SUBJECT: Forwards comments on 841126 draft NPDES Permit PA0047325.
 Flow & ph monitoring requested to be required only on days
 that discharges made to Sedimentation Pond S-2. Requests
 deletion of max daily & instantaneous max iron limits.

SUSQUEHANNA STEAM ELECTRIC STATION
NPDES DRAFT PERMIT COMMENTS
PERMIT NO. PA0047325
CCN 741326 FILE 012
PLE- 6614

Attached are the Pennsylvania Power and Light (PP&L) Company's comments on the Susquehanna Steam Electric Station's (Susquehanna SES) draft NPDES permit transmitted to us on November 26, 1984.

ATTACHMENT 1 (CONT)

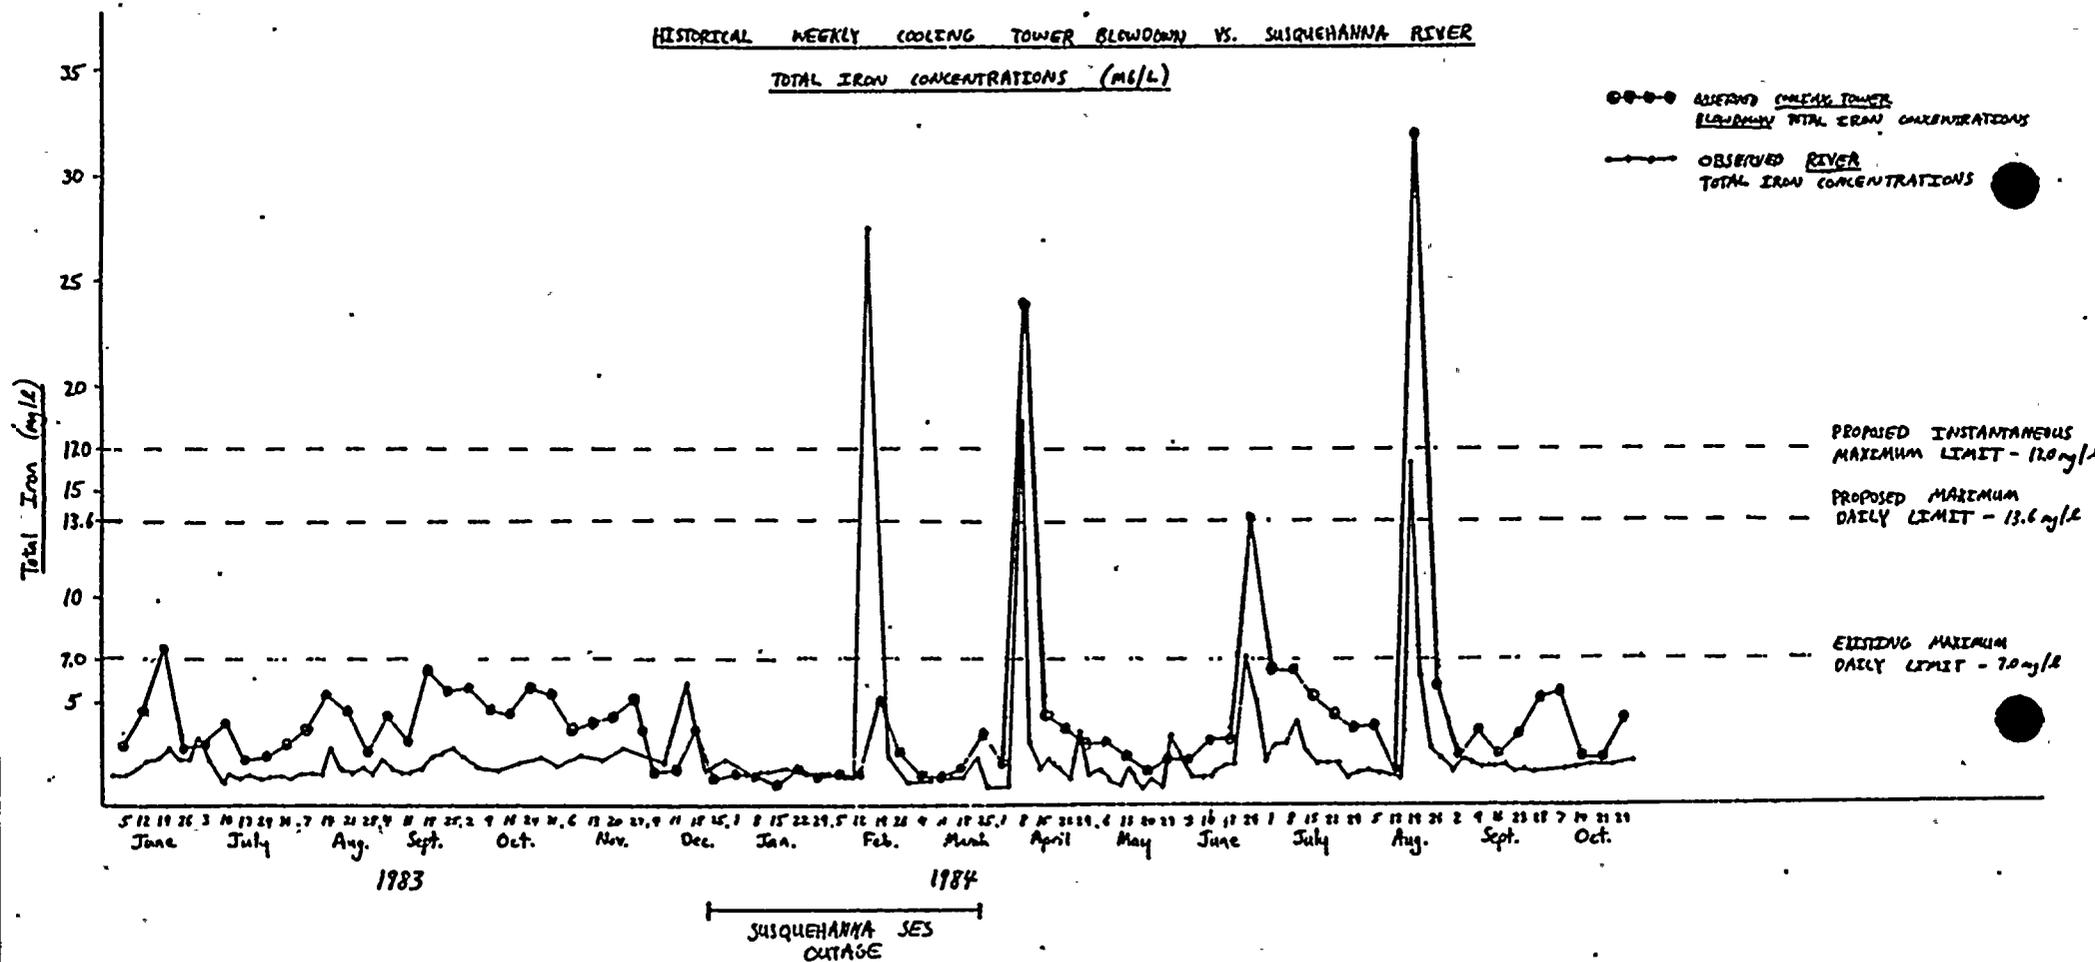
PP&L recommends the deletion of the maximum daily and instantaneous maximum limits or, at a minimum, the establishment of maximum limits which reflect the true variability in the effluent quality. If the Pa. DER insists on establishing maximum limits PP&L recommends use of a variability ratio of approximately six (based on maximum observed/average observed iron concentrations in both the raw water supply and cooling tower blowdown presented in Attachment 1). Using

this approach, the appropriate maximum daily limit would be 6.8 mg/l (monthly average limit) x 6 or 40.8 mg/l.
